Docket Item # 9 & 10
BAR CASE # 2012-00188 &
2012-00168

BAR Meeting
June 20, 2012

ISSUE: Permit to Demolish and Alterations
APPLICANT: Martha and Kenneth Gabriel by Rebecca Bostick
LOCATION: 108 Quay Street
ZONE: RM / Residential

STAFF RECOMMENDATION: Staff recommends approval of the application as submitted.

REAR ELEVATION
 1/4" = 1'-0"

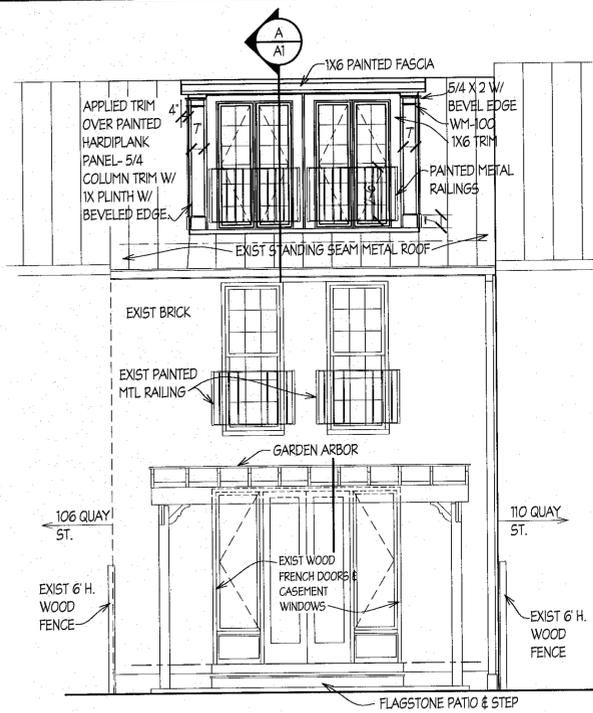
When the applicant initially submitted their BAR application, triangular windows were proposed on the side of the dormer, similar to the windows at 112 Quay Street, which Staff felt had little historic precedent on the Colonial Revival style. The applicant revised the dormer elevations and the rear dormer's side windows now have a more traditional rectangular form, though octagons and round windows were also used in these locations. Staff initially had concerns about the dormer height and depth, in that it encompasses the majority of the roof slope -- from the top of the roof to the rear wall. The proportions might be improved slightly if the dormer windows were set back from the rear wall two feet. However, upon seeing the other dormers approved within the development, Staff finds the proposed location of the rear dormer to be compatible with others in this development.

- C-7 All exterior walls shall comply with Table R302.1 of the 2009 USBC. Exterior walls within 5 feet from an interior property line shall have a fire resistance rating of 1 hour, from both sides of the wall. As alternative, a 2 hour fire wall may be provided. This condition is also applicable to skylights within setback distance. Openings in exterior walls between 3 and 5 feet shall not exceed 25% of the area of the entire wall surface (This shall include bay windows). Openings shall not be permitted in exterior walls within 3 feet of an interior lot line. Include in the submission the distance from the property line as well as percent of openings in rear shed roof dormer if openings are provided parallel with the property line.

FRONT ELEVATION
 1/4" = 1'-0"

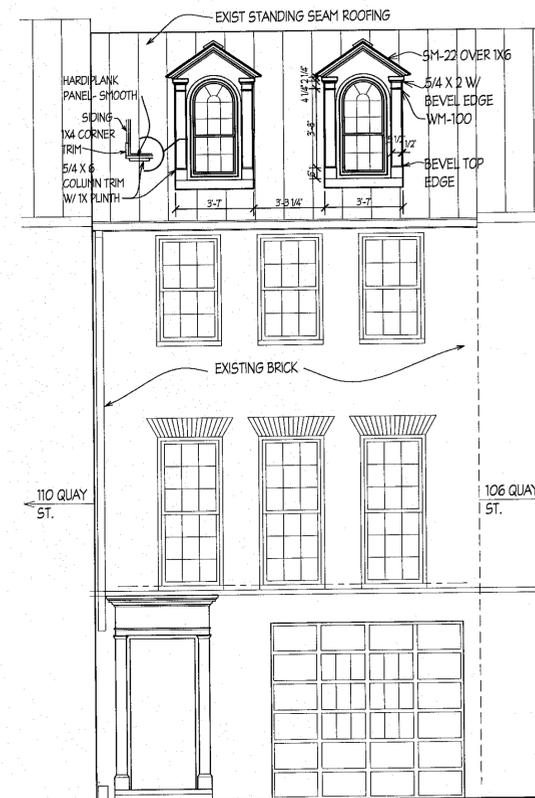
Staff has no objection to the front dormers, which are well proportioned and have Colonial Revival style detailing compatible with the architectural character of 108 Quay Street and the surrounding townhouses. While the shed form of the rear dormer is not generally recommended in *Design Guidelines*, the Board has routinely approved this dormer form in the immediate neighborhood and throughout the historic district, though generally on the rear elevation on interior lots. Staff surveyed the neighborhood and, of the original 86 townhouses, 15 have front dormers and 20 have rear dormers. In the block bounded North Union, Quay, North Lee and Queen Streets there are six rear dormers (four with shed style rear dormers and two with gable dormers (see below); only one house in the block has a front dormer). Staff was able to locate BAR approvals for five of the six rear dormers, the most recent being the dormer two doors down at 212 Quay Street on January 18, 2006 (BAR Case #2005-0298).
